PRODUCT CHANGE NOTICE

1. TITLE IRHM7250SE SOA Characteristics		2. DOCUMENT NUMBER FV5-C-20-0036
		3. DATE July 23, 2020
4. MANUFACTURER AND ADDRESS International Rectifier HiRel Products, Inc 205 Crawford Street Leominster, MA 01453		5. MANUFACTURER PART NUMBER See below for IR Part Numbers
		6. BASE PART NA
		7. NATIONAL STOCK NUMBER (NSN) NA
8. CAGE 69210	9. EFFECTIVE DATE July 23, 2020	10. GOVERNMENT NUMBER NA
11. POINT OF CONTACT Manufacturer's Representative or Account Specialist (978) 534-5776		12. DRAWING NUMBER NA
		13. SPECIFICATION NUMBER MIL-PRF-19500

IRHM7250SE

200V N-Channel SEE Hardened MOSFET in a TO-254AA package

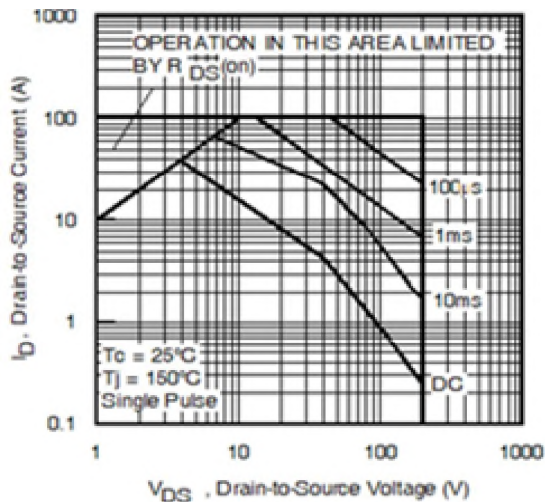
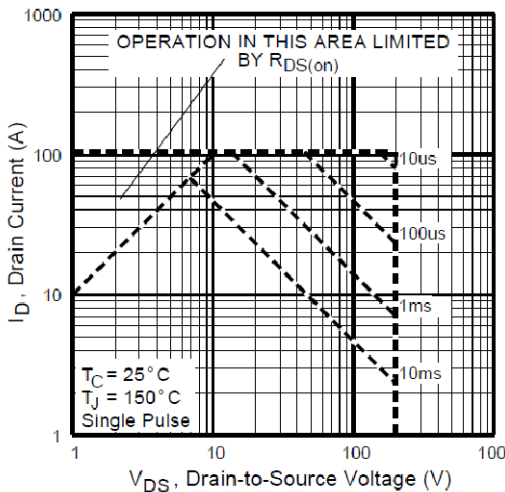
This GIDEP PCN is to announce specifications change/update in the Maximum Safe Operating Area (SOA) characteristics for the following International Rectifier Part No. Note that this change is related to part specification only, and not due to a die physical change.

Datasheet updated with new SOA characteristics including DC curve.
